February 1, 2012

Re: Vent Hole Questions for the La Sal Mines

Electrical wiring at the 900 Vent

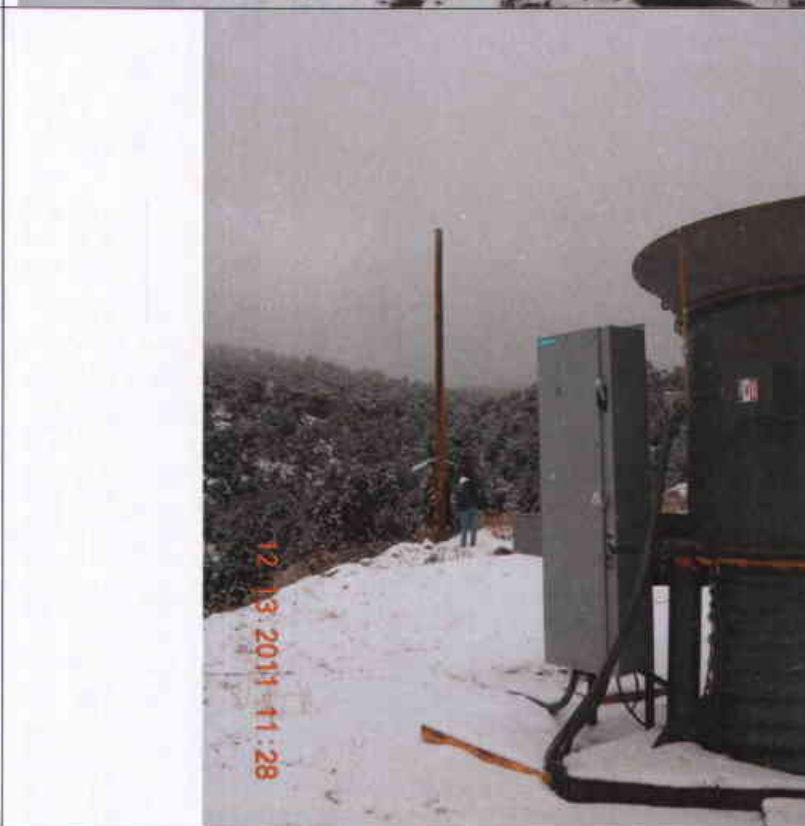
- The 900 vent was also a re-drilled hole and the former site has been reclaimed. Additional concerns included the electrical lines for this vent. Denison was at the site with the BLM in December and the electrical wiring for this vent and the 1050 vent were inspected. Denison followed up with a licensed electrician in Utah and is enclosing the specifications for the wiring at the site. In addition, MSHA has inspected these lines and indicated that armored cable is OK to be left on the ground. Photographs from the BLM inspection are also included.
